EVOLUTION PLANNING

RE: DA2020/1501 – 38 Undercliff Road, Freshwater – Amended Design

Amended DA

Figure 1: Previously amended design

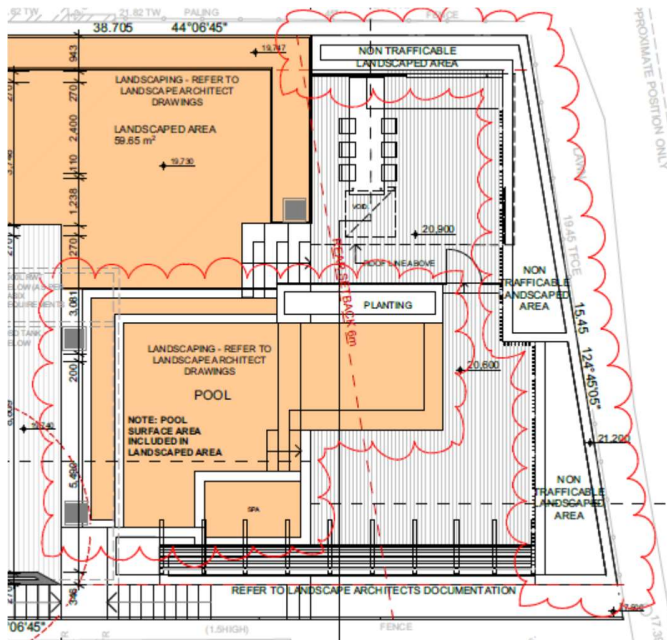
- Setback the secondary dwelling from Moore Lane by 1.5m and the creation of a landscaped zone and small deck for the use of the occupants of the secondary dwelling. The proposed setback will remove the requirement for the rear facing windows to be fire treated;
- A reduction in the area of the deck above the secondary dwelling and the garage accomplished by significantly increasing the width of the non-trafficable landscaped planter boxes, particularly from each of the side boundaries by up to 3.5m;
- A reduction in the size and further setting back of the proposed canopy from Moore Lane from ~1m to 3.75m;
- The removal of the privacy screen previously located along the eastern edge of the deck area and its replacement with a lower screen setback 4.9m from the lane.

This letter is accompanied by amended architectural drawings, prepared by Arkhaus, and an amended landscaping concept plan, prepared by COS Design. Refer to the extracts from the perspectives and floor plans below to compare the current proposal and the previous amended design.

Figure 3: Previously amended design

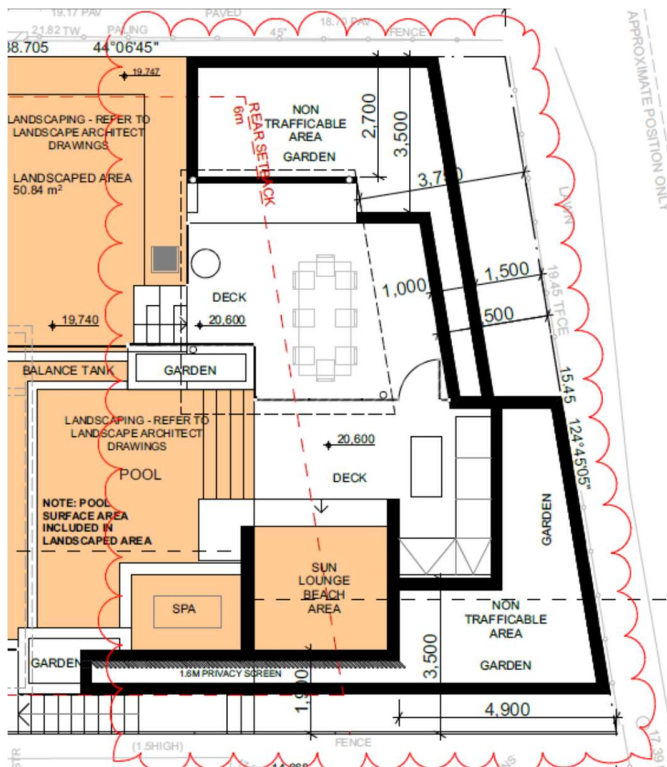
- modulating the rear wall by setting back the secondary dwelling component by 1.5m and creating visual interest at the rear by the inclusion of a private open space area for the occupants of the secondary dwelling, capable of accommodating a small table and chairs, and providing some landscaping at the rear at ground level;
- significantly increasing the area and widths of the non-trafficable landscaped planter beds surrounding the deck resulting in a dense landscaped environment wherever the deck is viewed from the Lane;
- increasing the setback of the proposed canopy from the Lane from ~1m to 3.75m;
- setting the privacy screen 1.9m back from the eastern boundary; increasing the setback of the eastern privacy screen from the Lane from ~2m to 4.9m; and, reducing the length of the screen to only provide privacy to the spa and sun lounge area.
